**TOWN OF FAIRFAX
STAFF REPORT
Department of Planning and Building Services**

TO: Fairfax Planning Commission
DATE: December 20, 2018
FROM: Ben Berto, Director of Planning and Building
LOCATION: 407 Cascade Drive; Assessor's Parcel No. 003-044-09
ZONING: Residential Single-family RS-6 Zone
PROJECT: Construction of a new single-family residence
ACTION: Use Permit and Design Review Permit; Application # 18-21
APPLICANTS/OWNERS: Shawn and Allison Madden
CEQA STATUS: Categorically exempt, §15303

407 CASCADE DRIVE

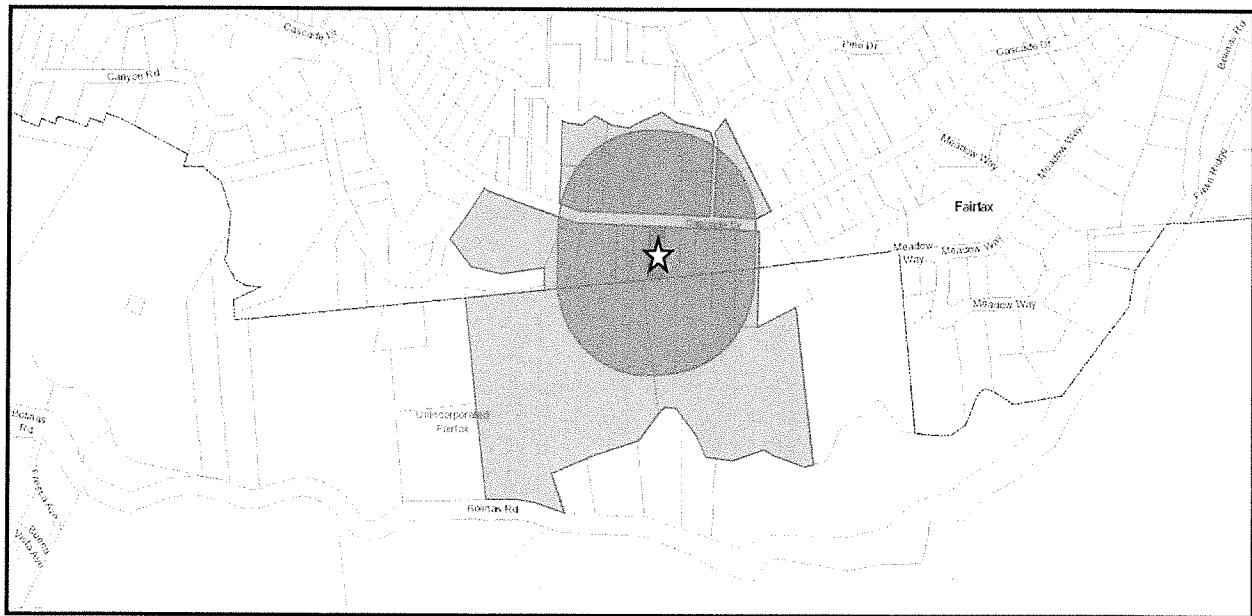
The residence continues to be relatively large for the neighborhood. However, all of the changes the applicants have made substantially improve its harmoniousness with other residences in the area. The additional articulation in the front, with two offset gable roof sections, substantially reduce street-facing boxiness. Similarly, the reduction in overall building height brings the maximum height and eave height close to those of its westerly neighbor. The west side setbacks exceed those of the west neighbor. The side fenestration of the two houses, where they align, are not a critical issue as the west neighbor's are pass-through windows on the stairway.

The easterly residential structure may be more of an issue with respect to relative building mass and bulk. Staff does not believe that light is too much of a problem, insofar as in the dead of winter the sun disappears behind the ridge to the south by mid-afternoon, before the proposed residence would cast additional shade on the east neighbor. In summer, the large valley oaks at 411 Cascade would also provide somewhat equivalent late afternoon shading as the proposed residence.

Staff continues to recommend that the overall building height be reduced by an additional foot (for a total reduction from the original design of approximately 3 feet).

accomplished would be by stepping the east side of the second floor in from the first floor, perhaps in front and behind the stairway area. This would also reduce the overall ridge and building height (less width with a sloped roof equals less height), and create more openness and light for the easterly neighbor.

Another potential issue for discussion concerns the second-story, rear-facing deck. The next-door neighbor at 411 Cascade noted potential rear yard privacy concerns. While the Pittosporum hedge on the shared property line will provide some screening, another option for consideration would be to require installation of a 6-foot solid wall on the west side of the deck.

The last recommended change is to include a medium height tree in the front yard area, to further soften the visual impact of the front façade. The applicant has indicated a desire to garden portions of the front yard. The tree could be a fruit tree to provide edible landscaping.

2. Prior to issuance of the building permit for the project the plans shall be amended as follows:
 - a. The maximum height shall be reduced by 1 foot, or to a maximum height of 25 feet, 9 inches.

- b. The existing Pittosporum hedge on the west property line shall be preserved except for the areas identified on the site to be removed to comply with Fire requirements.

- c. A tree with an anticipated height at maturity of at least 12 feet shall be incorporated into the landscape plan for planning in the front yard area.
